UNITED STATES PATENT AND TRADEMARK OFFICE

APPLICATION NO.	FILING DATE	FIRST NAMED INVENTOR	ATTORNEY DOCKET NO.	CONFIRMATION NO.
10/763,139	01/22/2004	Cheng-Hsun Tsai	3304.2.118	6399
21552	7590	06/28/2005	EXAMINER	
MADSON & METCALF GATEWAY TOWER WEST SUITE 900 15 WEST SOUTH TEMPLE SALT LAKE CITY, UT 84101			DOAN, THERESA T	
			ART UNIT	PAPER NUMBER
			2814

Office Action Summary

DETAILED ACTION

FIG. 2

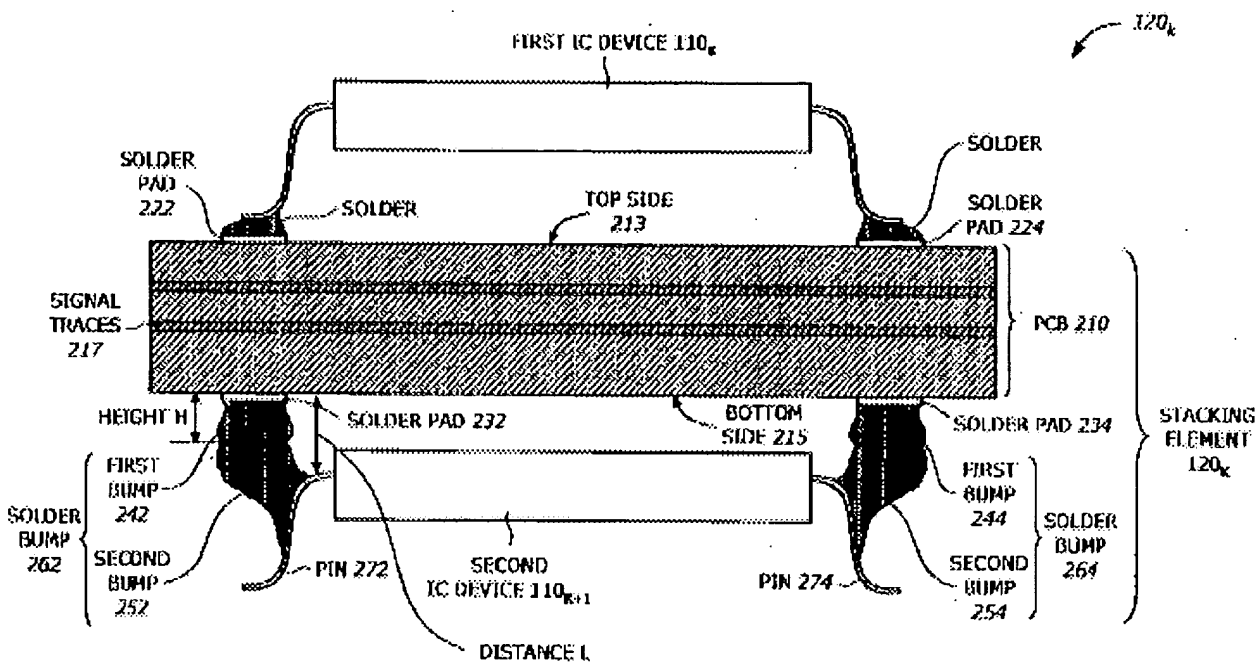
Regarding claims 1, 9 and 15, Nguyen (Fig. 2) discloses a stacked IC comprising: a first IC package unit $110_{(K+1)}$ comprising an IC chip (paragraph [0014]), an encapsulant resin (paragraph [0014], lines 13-14 and lines 19-24), and a plurality of lead wires 272/274 comprises a first end encapsulated by the encapsulant resin and a second end extending outside the encapsulant resin, wherein the second end extending outside the encapsulant resin comprises first and second soldering portions (see Fig. 2); a second IC package unit $110_{(K)}$ having the same structure as the first IC package unit $110_{(K+1)}$ (paragraph [0014], lines 19-24); and an interface layer 210 sandwiched between the first IC package unit $110_{(K+1)}$ and the second IC package unit $110_{(K)}$, and having first and second sides with a plurality of soldering pads 222/224 and 232/234, wherein each first soldering portion of the first IC package unit $110_{(K+1)}$ is connected to corresponding soldering pad 232/234 on the first side of the interface layer 210 via a

solder bump 262/264, and each second soldering portion of the second IC package unit 110_(K) is connected to corresponding soldering pad 222/224 on the second side of the interface layer 210 via a soldering material other than the solder ball (not labeled, see Fig. 2), thereby achieving electrical connection between the first IC package unit 110_(K+1) and the second IC package unit 110_(K) (paragraph [0020], lines 1-5). Nguyen (Fig. 2) further discloses that the first and second IC units 110_(K+1) and 110_(K) are selected from TSOP (paragraph [0014], lines 19-24). It is noted that one skilled in the art would recognize that the first end of the lead wire 272/274 would be electrically connected to the IC chip encapsulated in the encapsulant resin in order to transfer the data signals to and from the IC chip, as taught by Fig. 8 of King.

Nguyen does not disclose that the solder bump 262/264 formed on the first soldering portion of the lead wire 272/274 is a solder ball.

Regarding claim 2, Nguyen (Fig. 2) further discloses that the first and the second soldering portions are in the vicinity of and distant from the encapsulant resin, respectively.

Regarding claims 3-4, 10 and 16, Nguyen (Fig. 2) further discloses that each of the first and the second soldering portions is substantially parallel to the interface layer 210, and the interface layer 210 is made of a hard dielectric material of FR-4 (paragraph [0019]).

Regarding claims 6, 12 and 18, Nguyen (Fig. 2) further discloses that the IC chip for each of the first IC package unit $110_{(K+1)}$ and the second IC package unit $110_{(K)}$ is selected from a group consisting of a memory chip (paragraph [0014], lines 15-19).

Regarding claims 7-8 and 13-14, Nguyen (Fig. 2) also discloses that each of the first IC package unit $110_{(K+1)}$ and the second IC package unit $110_{(K)}$ is a thin small outline package (TSOP) or a quad flat pack (QFP) (paragraph [0014], lines 19-24).
